Appendix I of RNTPC
Paper No. A/YL-KTN/1042B

**APPLICATION FOR PERMISSION
UNDER SECTION 16 OF
THE TOWN PLANNING ORDINANCE
(CAP. 131)**

(a) Proposed use(s)/development 擬議用途/發展	Proposed Temporary Animal Boarding Establishment (Dog Kennel) for a Period of 3 Years and Filling of Land (Please illustrate the details of the proposal on a layout plan) (請用平面圖說明擬議詳情)

This letter intends to supersede our letter dated 9.9.2024. Our response to the comments of the CE/MN, DSD is as follows:

Figure 8

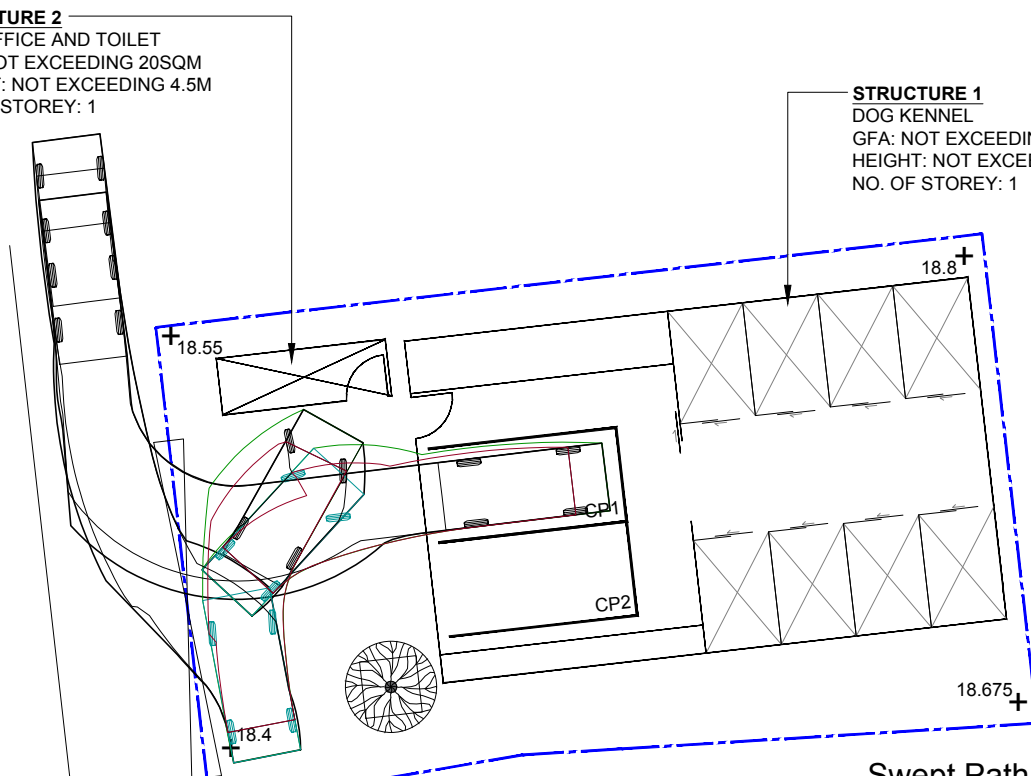
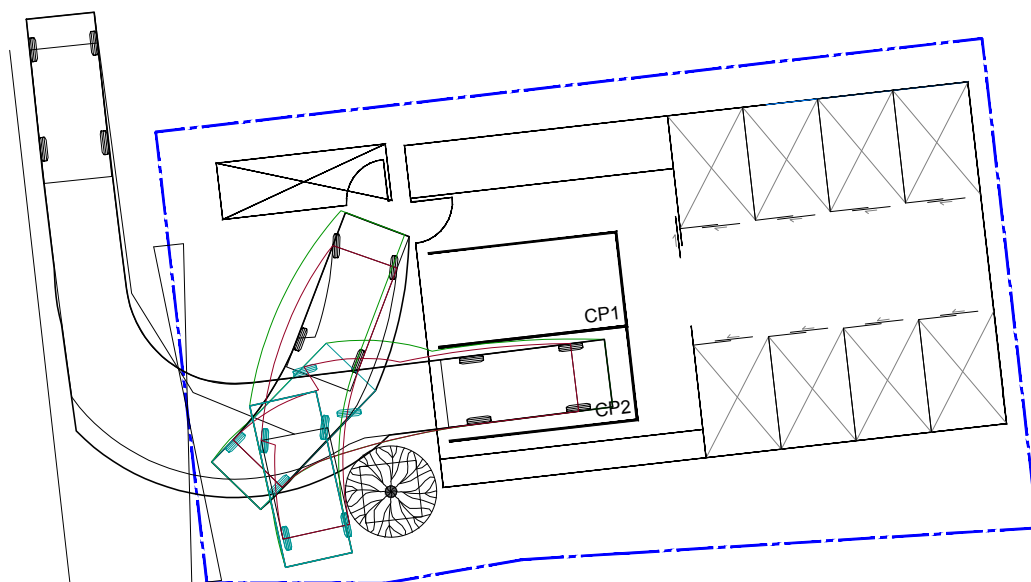
Transport Department's comments	Applicant's response
(a) The applicant should demonstrate the smooth manoeuvring of vehicles to / from the site. Reverse of vehicles in local road may induce road safety hazard;	Noted. Please refer to the swept path analysis in the attachment. The proposed parking spaces have been moved into the temporary structure so that manoeuvring space is available as shown in the updated Figure 3.
(b) The applicant should note the local access between San Tam Road and the site is not managed by this Department.	Noted.
